**ADDENDUM #1**  
**TMWRF AIR COMPRESSOR REPLACEMENT**  
**BID #17/18-021**  
**BIDS DUE NO LATER THAN: 1:45 PM ON MAY 14, 2019**  
**PUBLIC BID OPENING: 2:00 PM ON MAY 14, 2019**

CITY OF SPARKS  
TMWRF AIR COMPRESSOR REPLACEMENT PHASE II  
ELECTRICAL PARTIAL FLOOR PLAN

JOB NO.  
A72JK  
DRAWING NO.  
**E3.2**  
SHEET NO.  
11 OF 12

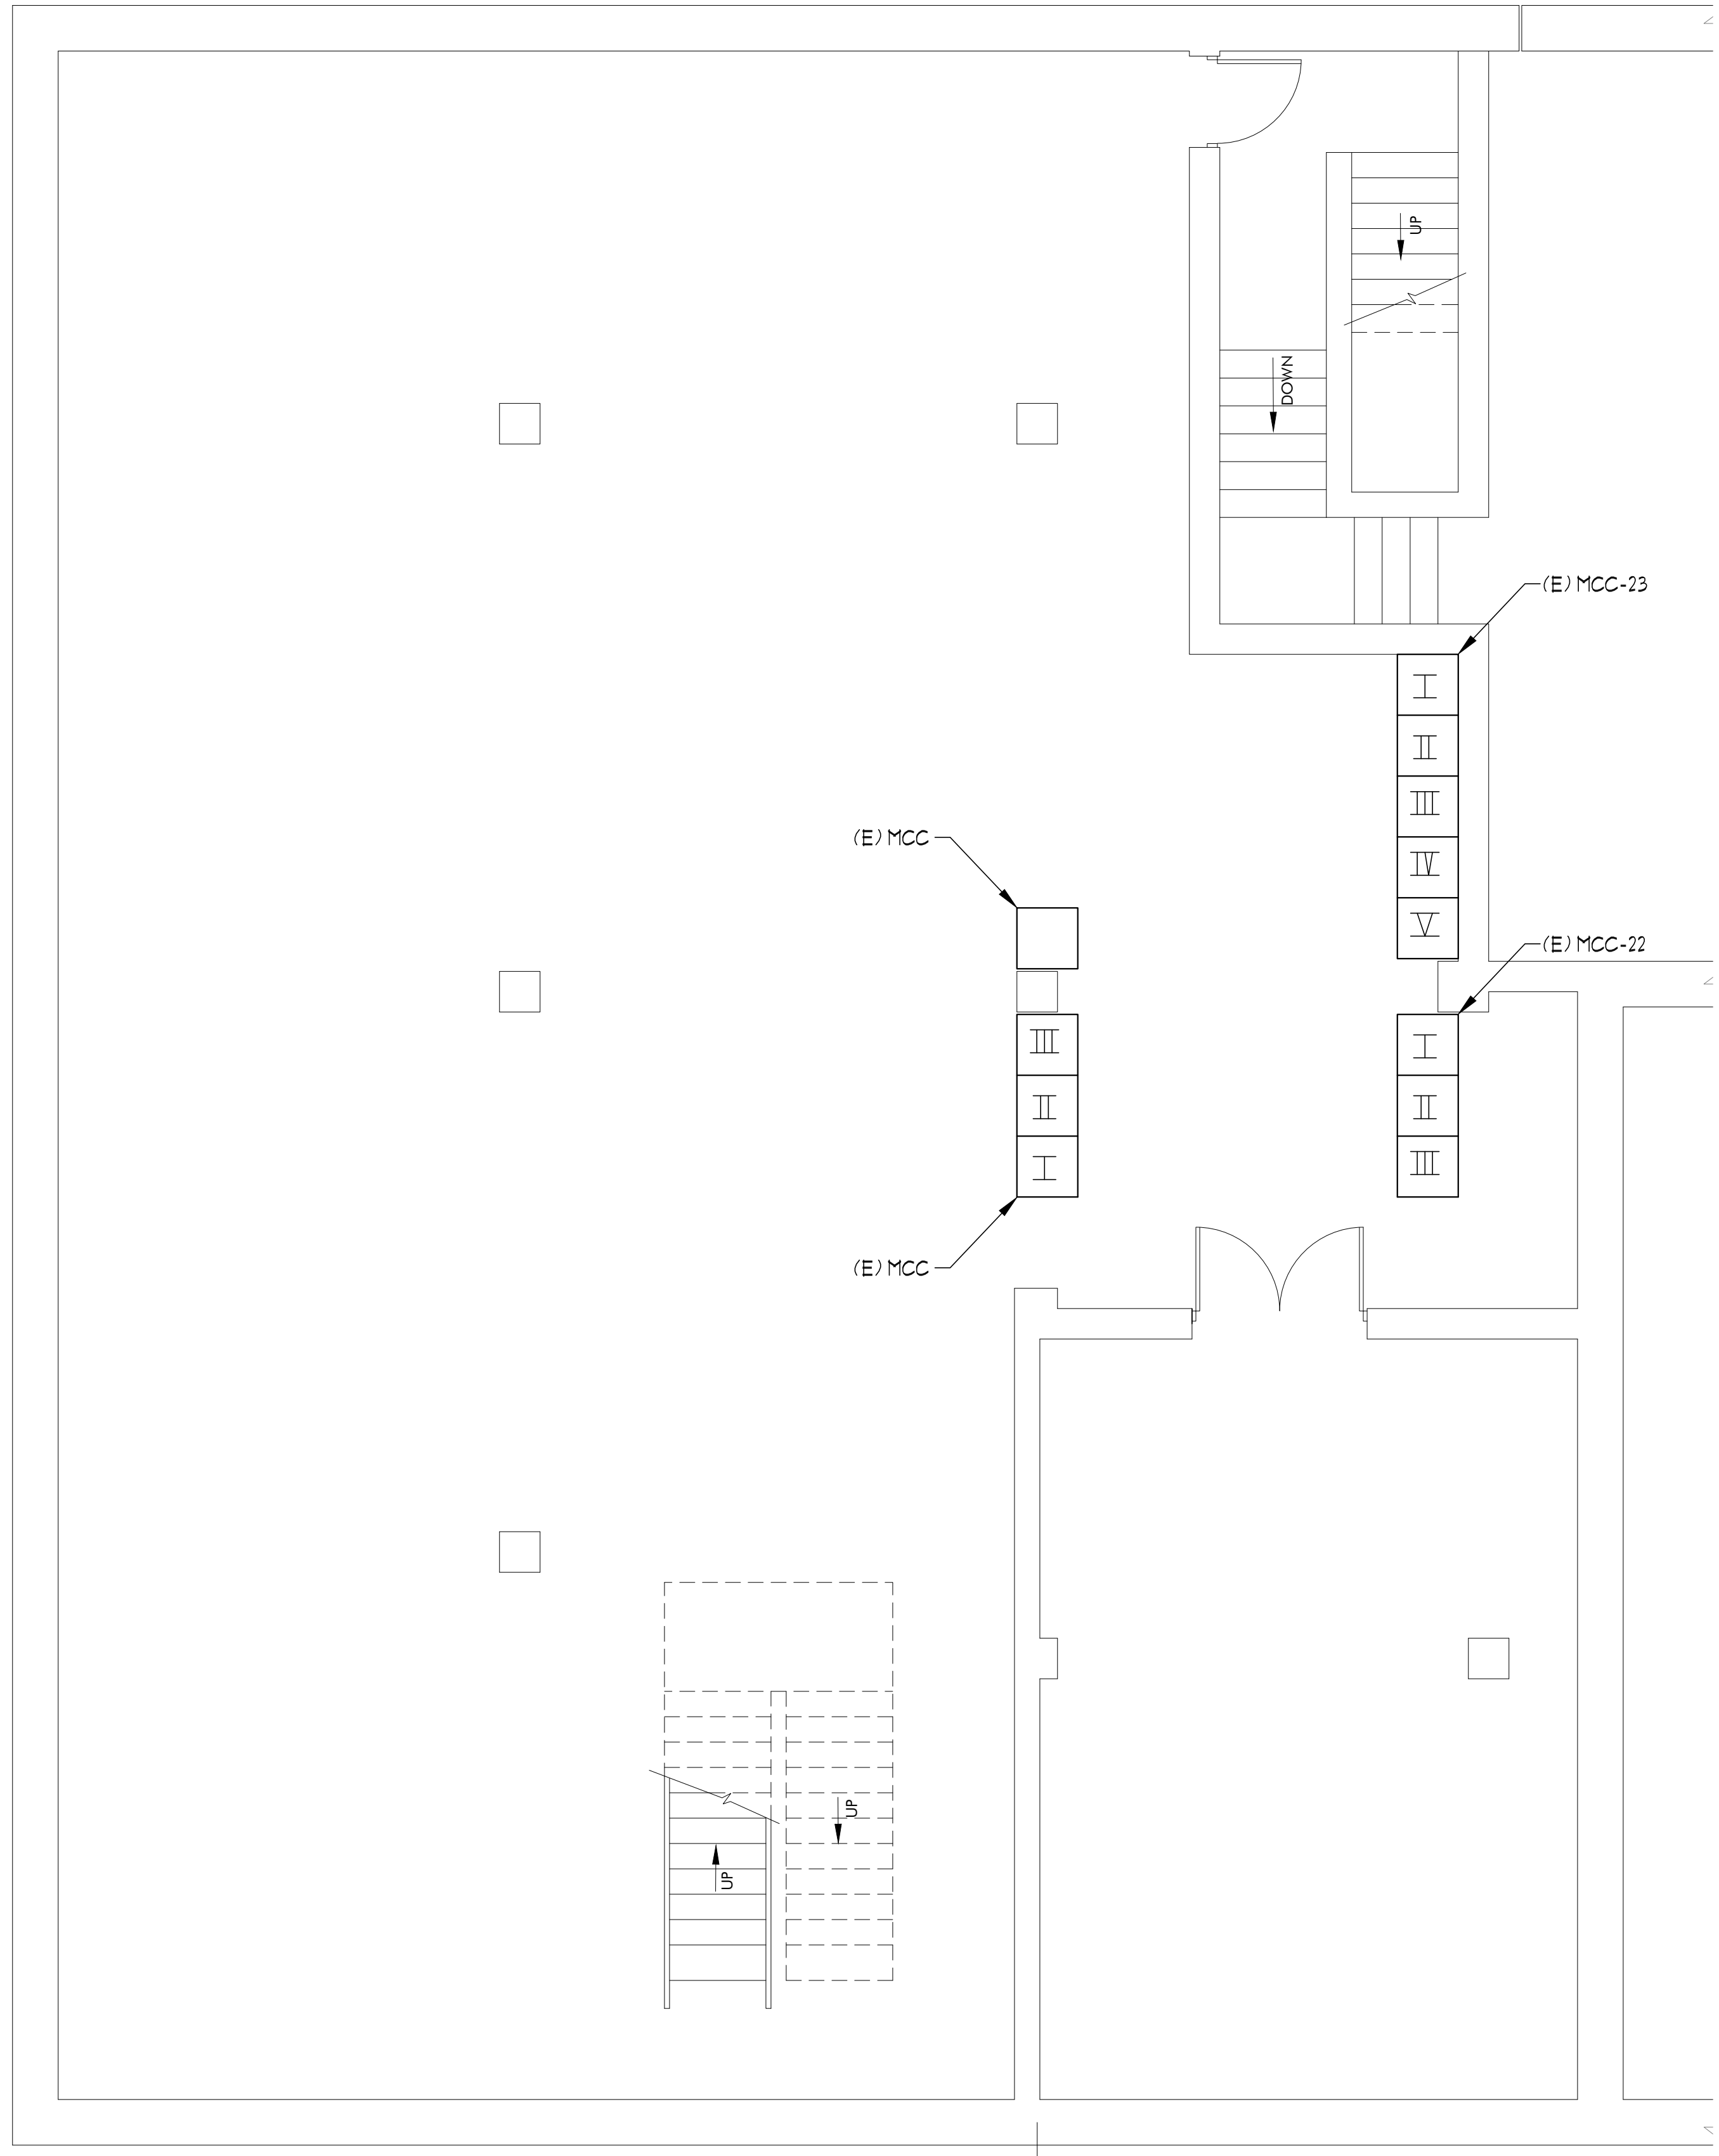
Sheet E3.2 has been revised and is included as Page 2 to this Addendum. The existing breaker feeding Air Compressor B is 200A.

- ① REMOVE AND RETIRE (E) 200A BREAKER IN MCC-22 AT POSITION #2C FEEDING (E) AIR COMPRESSOR #2.
- ② PROVIDE AND INSTALL (N) 175A BREAKER IN MCC-22 AT POSITION #2C TO FEED (N) AIR COMPRESSOR #2.
